Certificate of Appropriateness

**MILWAUKEE
HISTORIC
PRESERVATION
COMMISSION**

3248 W. MC KINLEY BL.

PTS ID 46570 COA, porch repairs

Center match or tongue-and-groove flooring

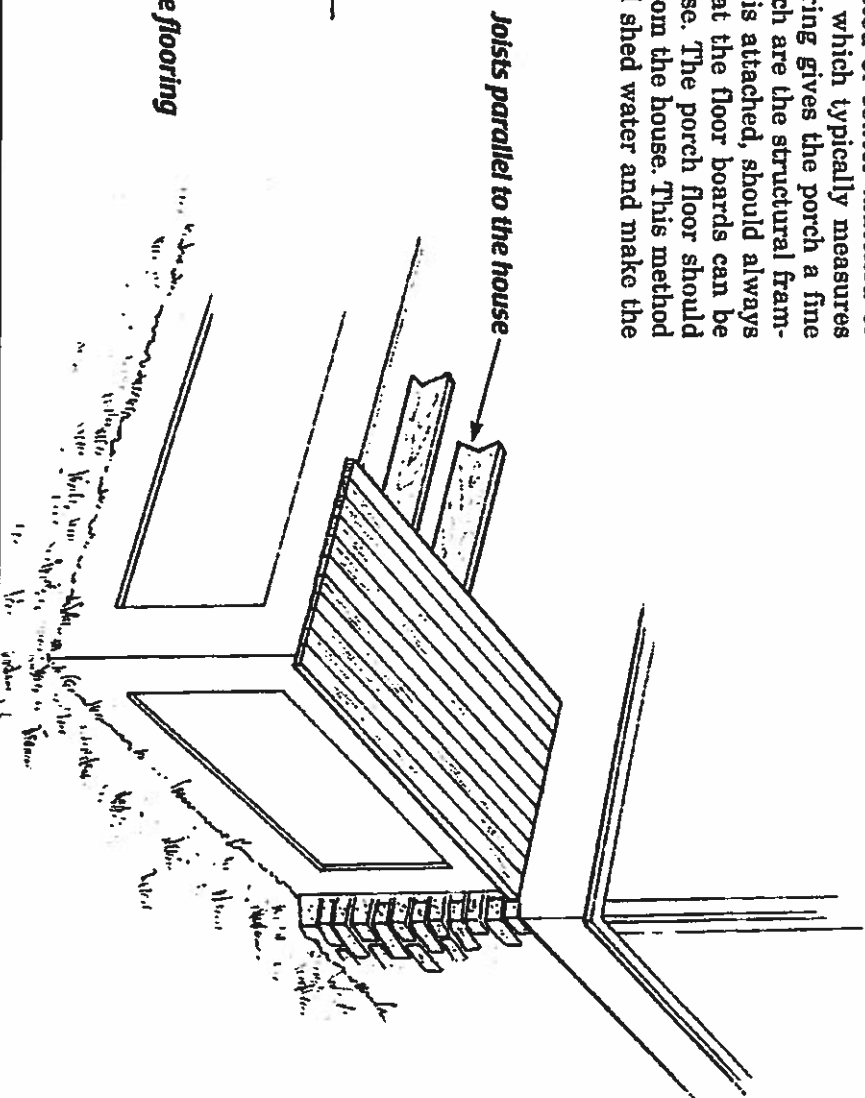
New porch floor to be center match material installed as illustrated

Porch Skirting

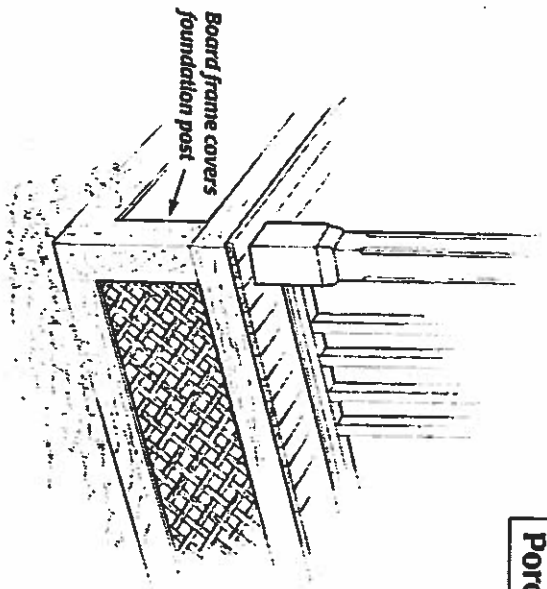
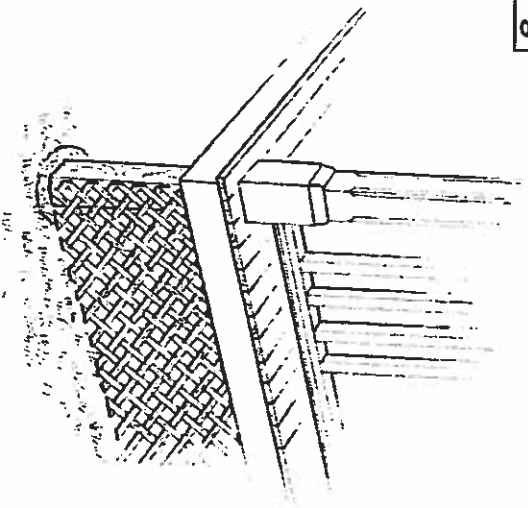
Skirting, such as this lattice panel, enclosed the area beneath the porch floor. It should always be installed with a continuous board frame around it that is wide enough to cover the rough framing lumber that supports the porch deck.

Do not install a lattice skirting without a frame around it. The rough framing lumber that supports the porch will show through and the row edges of the lattice look unfinished.

Porch skirting beneath the deck must be done with a full frame as illustrated in the left drawing. The frame can be filled with lattice as shown or vertical boards typically spaced no more than 1" apart.
